## Product Change Notification / CENO-21UTEV408

CCB 5141 Final Notice: Qualification of MTAI as an additional final test site for selected ATECC108A-SSxxx-x, ATECC508A-SSxxx-x, ATECC608A-SSxxx-x, ATECC608B-SSxxx-x and ATSHA204A-SSxxx-x device families available in 8L SOIC (3.90mm) package.

## Pre and Post Change Summary

### PCN #: CENO-21UTEV408

# Tube - Drawing

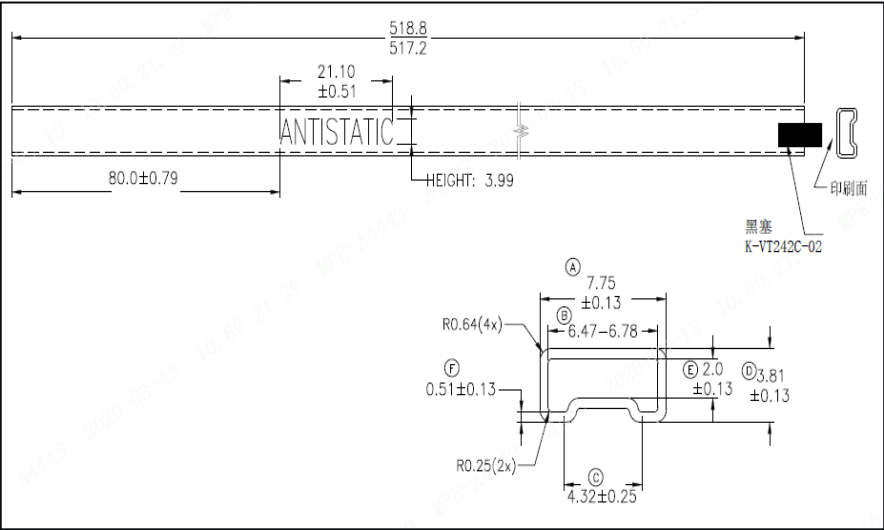
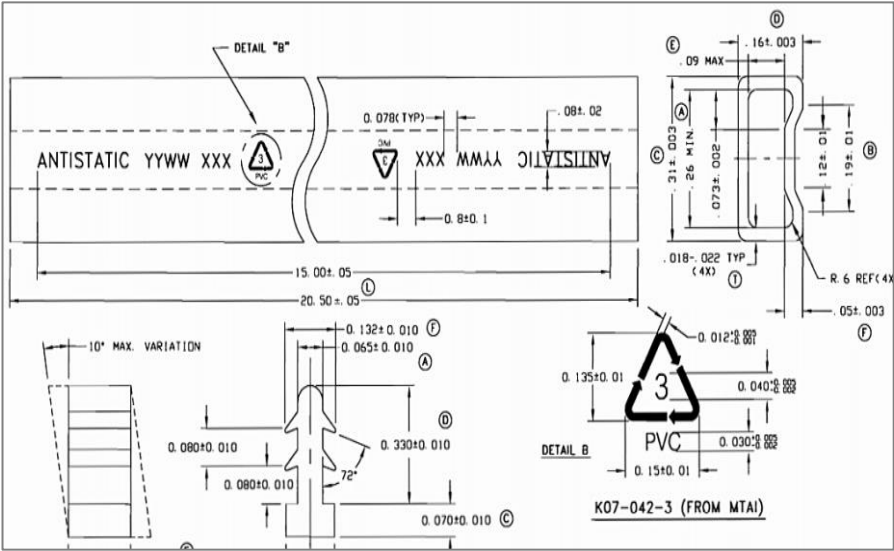
Length	Dimension	Color
20.00 +/- 0.03 inch (518 +/- 0.8 mm)	See on drawing	Clear

Length	Dimension	Color
20.50 +/- 0.05 inch (520.7 +/- 1.2 mm)	See on drawing	Clear

# Tube - Dry Pack Packing Method

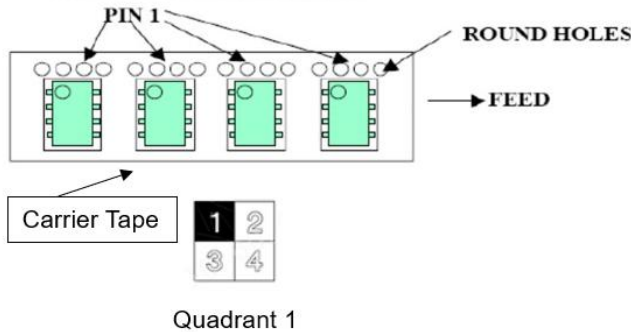
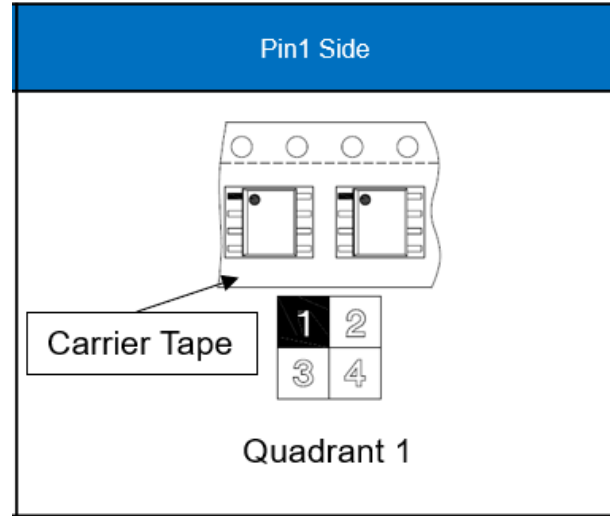
Drawing number	Dimension W x L x H (cm)	Drawing number	Dimension W x L x H (cm)																												
M02-010	12.9x56.5x8	M01-022 (PP)	15.5x62.0x14.0	1 per 1																											
		M01-028 (C4)	28x63.5x11	2 per 1																											
		M01-029 (C6)	28x63.5x15.5	3 per 1																											
		M01-030 (C8)	28x63.5x20	4 per 1																											
		M01-040 (S6)	43x59x19	6 per 1

# Tape and Reel – Carrier Tape

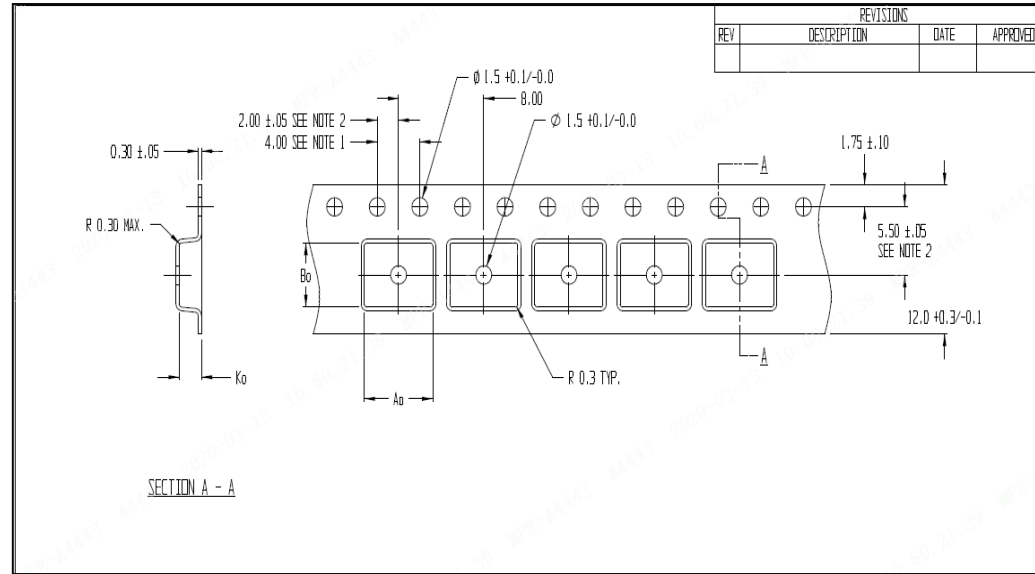
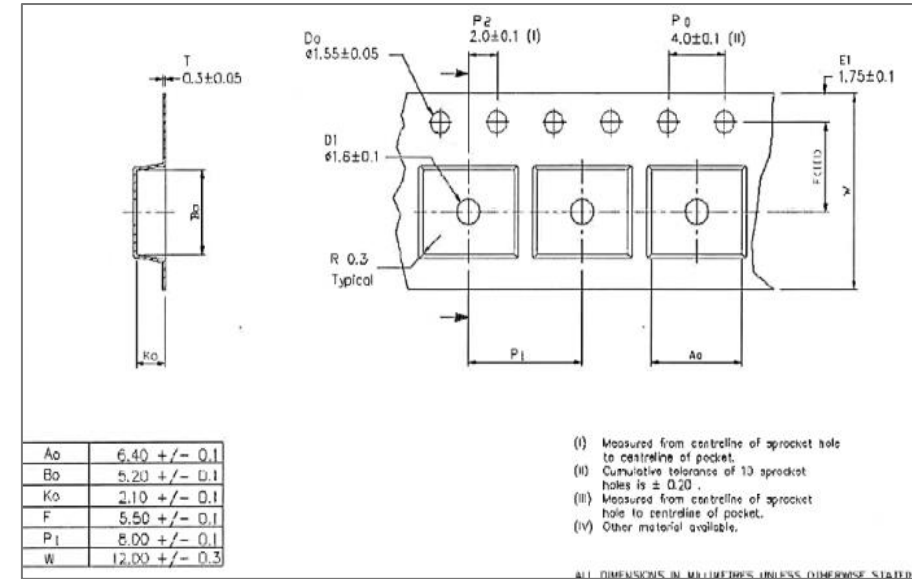
Plant	W (mm.) $\pm 0.3$ or Specific	P (mm.) $\pm 0.1$ or Specific	A0 $\pm 0.1$ or Specific	B0 $\pm 0.1$ or Specific	K0 $\pm 0.1$ or Specific	Thickness
ASSH	12	8	6.40	5.20	2.10	-
MTAI	12	8	6.40	5.20	2.10	-

# Tape and Reel – Cover Tape

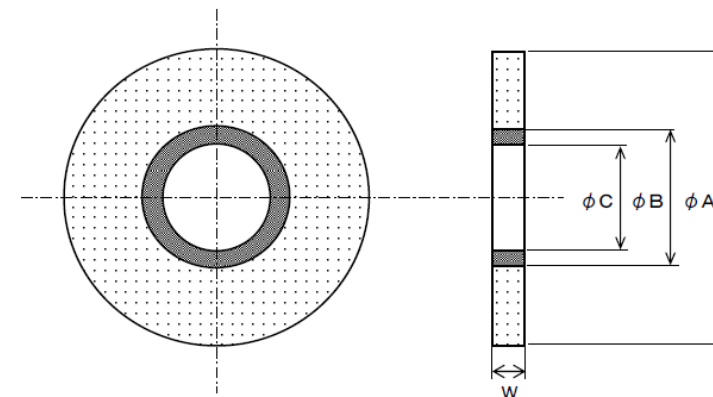
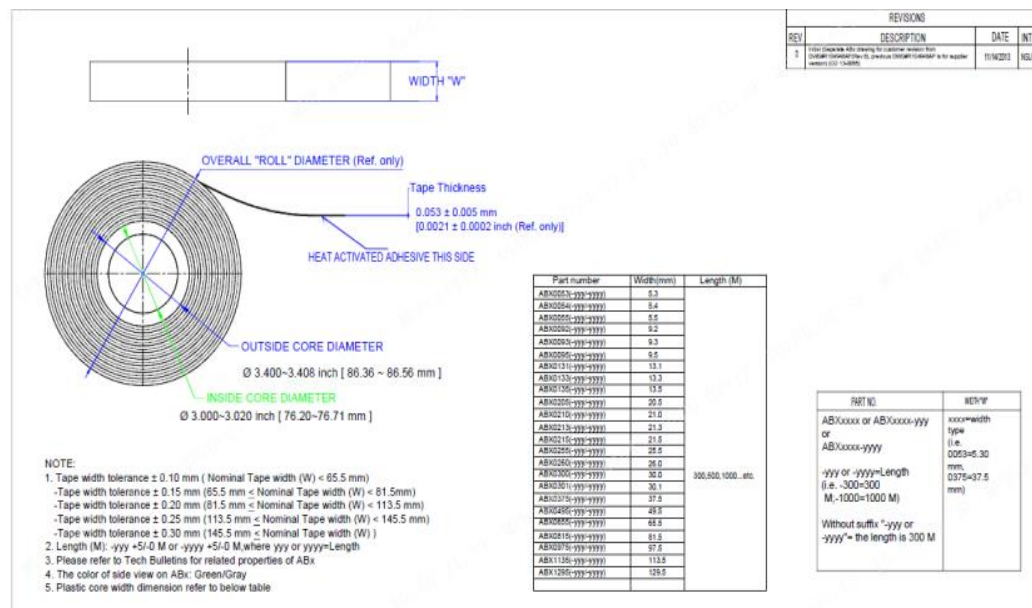
Plant	Carrier Width	Width "W" (mm)	Thickness (mm)	Sealing Mythology
ASSH	12mm	9.2+/-0.07	0.053 ±0.005	Heat seal
MTAI	12mm	9.05+0.05/-0.15	0.050 ±0.010	Heat seal

# Tape and Reel –Dry Pack

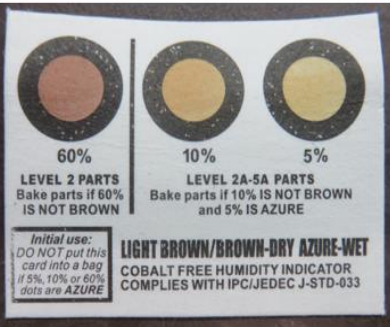
Inner box		Carton		Number of Inner box(es) per carton																						
Drawing number	Dimension	Drawing number	Dimension																							
	W x L x H (cm)		W x L x H (cm)																							
M02-015 (Small)	37x35.1x5.3	M01-044 (SM)	37.0x38.0x11.0	1 : 1																						
		M01-045 (S4)	37.0x38.0x22.5	3 : 1																						
		M01-046 (S5)	37.0x39.0x39.0	6 : 1																						
		M01-047 (S3)	42.0x66.0x39.0	11 : 1
